RE: 10 CFR 71.95(a)(3) report for CoC number USA/9314/B(U)-96

QSA Global, Inc. is making a report under 10 CFR 71.95(a)(3) concerning the Model 976 Series Type B packages (CoC 9314). During the review of a component, prior to an additional purchase, an issue was identified where the package configuration under the Type B certificate may not have been observed in making Type B shipments.

- R97600 Rev D, R85590 Rev K, R3056 Rev H & R1911 Rev H
- Drawing Change Table for Model 976 Series Packages (8/8/2018)
- CR 2161 Root Cause Analysis & Corrective Action Plan

Drawing Change Table for Model 976 Series Packages (8/8/2018)

SHEET 4 OF 6

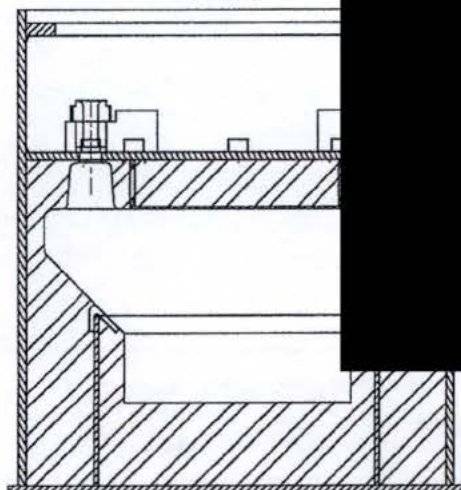
Change Location	Summary Change	Change Reported Pursuant to 71.95	Impact of Change on Units Previously or Currently in Use under the Certificate	Action Taken By QSA Regarding Affected Units
R85590 Rev K, Sheet 4	Corrected typographical error in word "Lock" in reference to the mounting plate.	No	No change to package construction or design. Change made for accuracy.	None. Not applicable.
R85590 Rev K, Sheet 4	Added identification as "NITS" to the roll pin and expansion plugs.	No	No change to package construction or design. Change made for consistency of identification of components not important to safety on the drawing.	None. Not applicable.
R85590 Rev K, Sheet 4	Replaced "typical" with "Reference" in regards to the source connector depiction on the drawing.	No	No change to package construction or design. Change made for accuracy and clarity of terminology use. The intent of this depiction was to show a source connector inserted into a source holder assembly but not to imply that all eight source holder assembly must contain a source connector to comply with a Type B shipment.	None. Not applicable.

SIZE A	DWG. NO. R85590	REV K
	SCALE: NONE

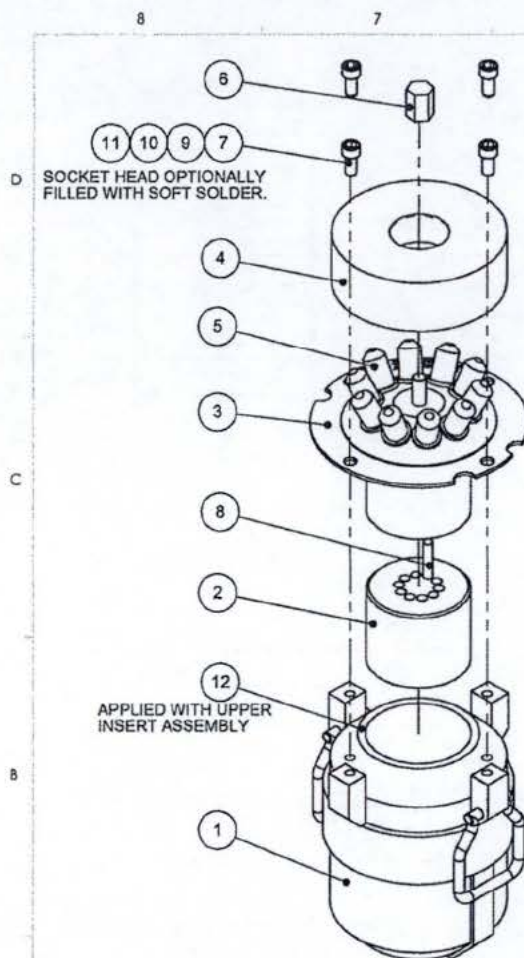
R85590 Rev K, Sheet 6	Corrected typographical error in word "equally" in Note 1.	No	No change to package construction or design. Change made for accuracy.	None. Not applicable.
